COMMITTEE OF THE WHOLE MARCH 24, 2003

**ZONING BY-LAW AMENDMENT FILE Z.02.016
SITE DEVELOPMENT APPLICATION FILE DA.02.066
MINGLEHAZE INVESTORS INC.**

Attachment 2
 FILE NO.: DA.02.066
 Z.02.016
 October 16, 2002
 Not to Scale

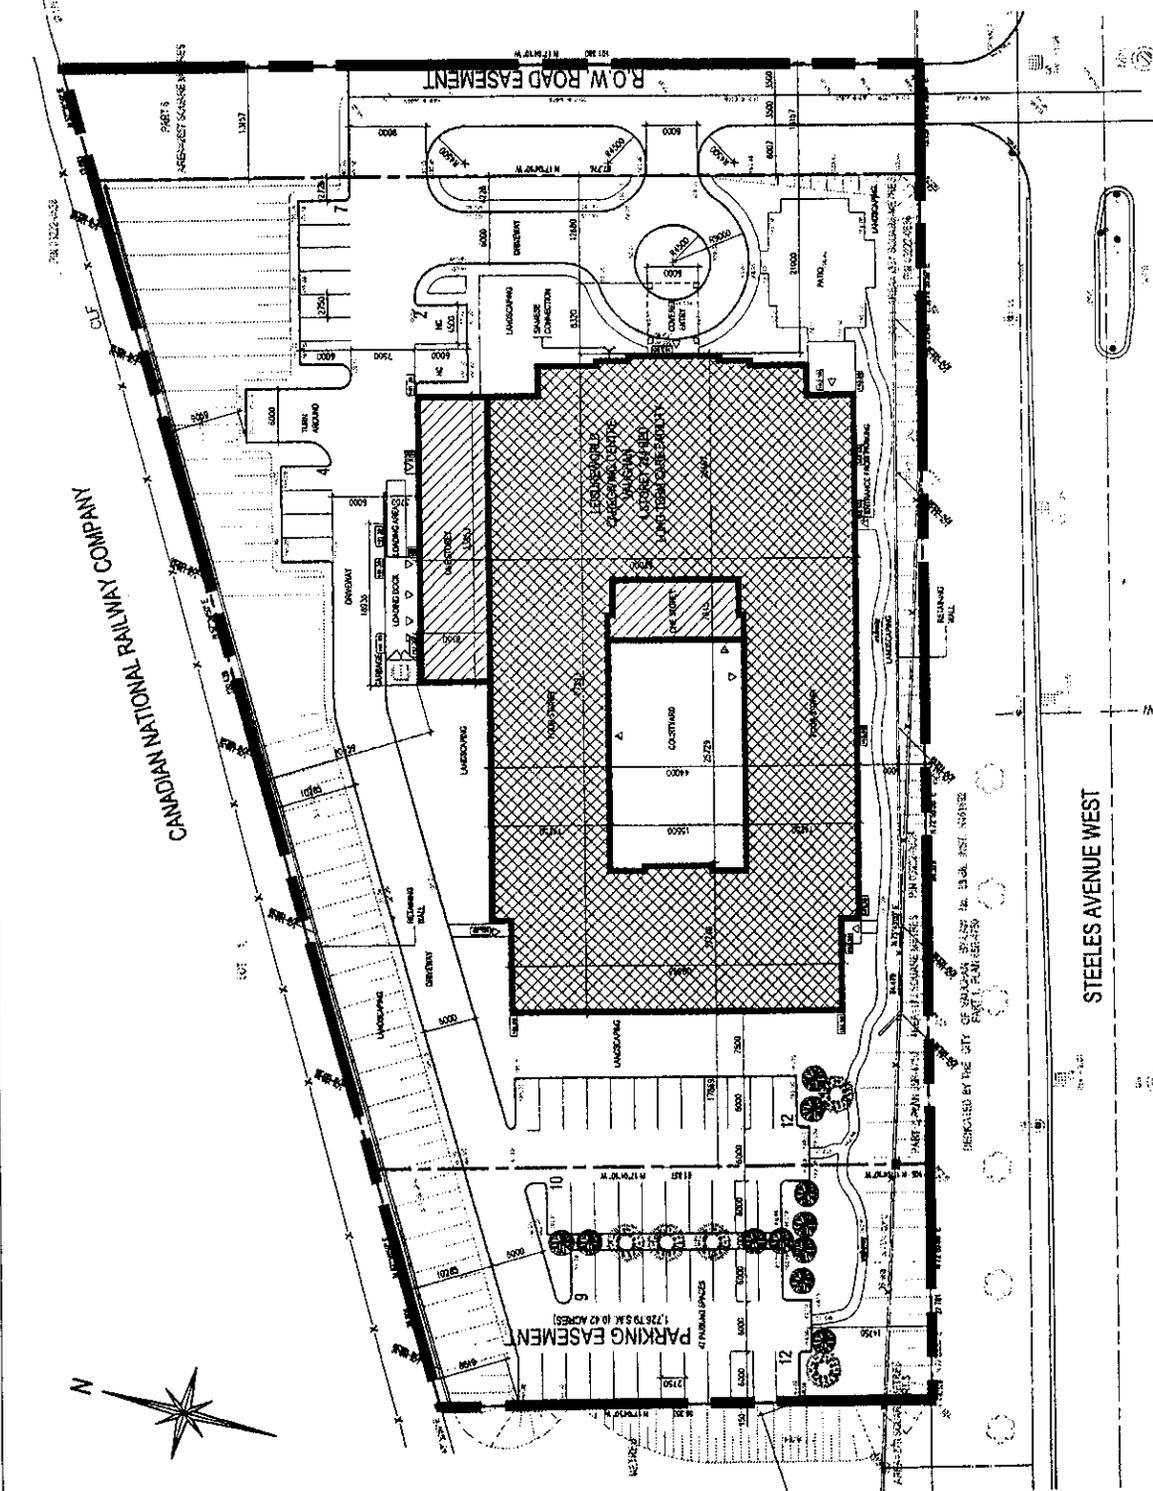
- as per City of Vaughan Standards, stormwater management is required for this site. The maximum allowable discharge is 180L/s/Ha. All storm events up to and including the 100 year storm shall be controlled on site. CN and TRCA approval is required.
- provide retaining wall details on plan.
- a Noise Report is to be submitted to the Engineering Department for review and approval.
- City of Toronto approval is required for sanitary and servicing.
- a separate fire and domestic waterline is required from the streetline.
- provide additional elevations 2m beyond the property boundary. Show all existing ground utilities.
- a Certificate of Approval from the MOEE for methane venting system is required.

The Engineering Department's remaining comments have been red-lined on the plan and forwarded to the applicant for revision.

1. This application is subject to payment of the Infrastructure Design and Construction Branch Development Review Fee, as identified in By-law No. A-197-96-62.
2. The details of the site access shown on the site plan drawing do not match with the details provided on drawing No. G1 prepared by Earth Tech. The details must be co-ordinated.
3. The Region of York currently is designing the York Peel Sanitary Sewer Forcemain adjacent to this site. The details of the sanitary sewer together with any permanent or

4. This Department has reviewed the Traffic Impact study prepared by Itrans Consulting Inc. dated April 2002 and has no objections in principle to the recommendations for the intersection of Steeles Avenue and Gihon Spring Drive. However, the Region suggests that a westbound right turn lane consisting of a minimum 3.5m wide lane with a 30.0m parallel section and 60.0m taper be constructed at the site access.

5. The site plan drawing together with the Traffic Impact Study, indicate that Gihon Spring Drive may be extended northerly into the overall property as a municipal street under the jurisdiction of the City of Vaughan. The access from Steeles Avenue and its internal location should be designed to mirror the existing conditions of the Steeles Avenue/Gihon Spring Drive intersection. It is not necessary to construct the access to its full width at this time. Any taper to a minimum condition could take place beyond the limits of Steeles Avenue.

6. The Owner shall convey to the appropriate road authority, a 15.0m by 15.0m daylighting triangle in the northwest and northeast corner of the future municipal street, free of all encumbrances, to the satisfaction of the appropriate road authority.
